Product/Process Change Notice (PCN)				
<input checked="" type="checkbox"/> Major Change <input type="checkbox"/> Minor Change				
PCN Number: PCN_ TBL PCB H. 5.08 mm _20260501 Affected Series: WR-TBL Affected Part Number: see table below PCN Date: 2026-02-02 (YYYY-MM-DD) Effective Date: 2026-05-01 (YYYY-MM-DD)	Change Category: <input type="checkbox"/> Equipment/Location <input type="checkbox"/> General Data <input type="checkbox"/> Material <input type="checkbox"/> Process <input checked="" type="checkbox"/> Product Design <input type="checkbox"/> Shipping/Packaging <input type="checkbox"/> Supplier <input type="checkbox"/> Software			
Contact: Product Management Phone: +49 (0) 7942 - 945 5001 Fax: +49 (0) 7942 - 945 5179 E-Mail: pcn.eican@we-online.com	Datasheet Change: <input checked="" type="checkbox"/> Yes <input type="checkbox"/> No Attachment: <input checked="" type="checkbox"/> Yes <input type="checkbox"/> No

DESCRIPTION OF CHANGE: To improve the processability, Würth Elektronik eiSos will change the production site of WR-TBL series mentioned. This implies changes in design, tolerances, layout recommendations. Aesthetics changes may occurred but it does not have an impact

a. 6913115000xx

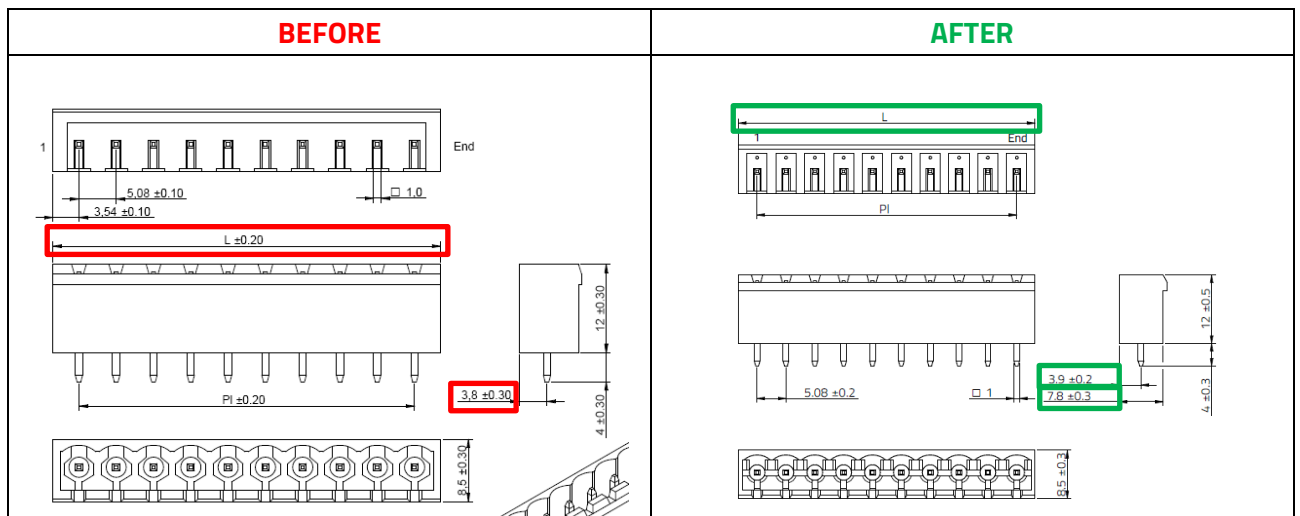
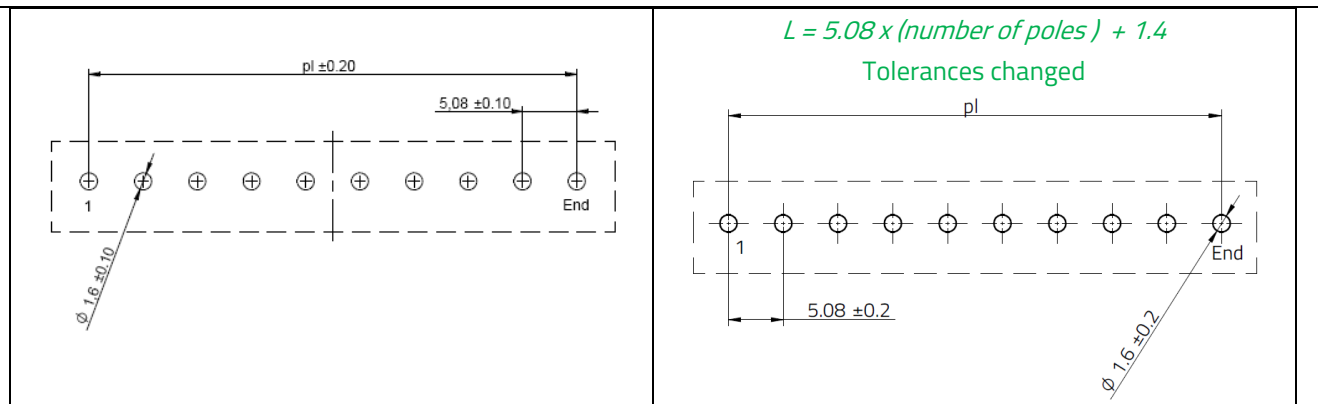
2. Design Changes
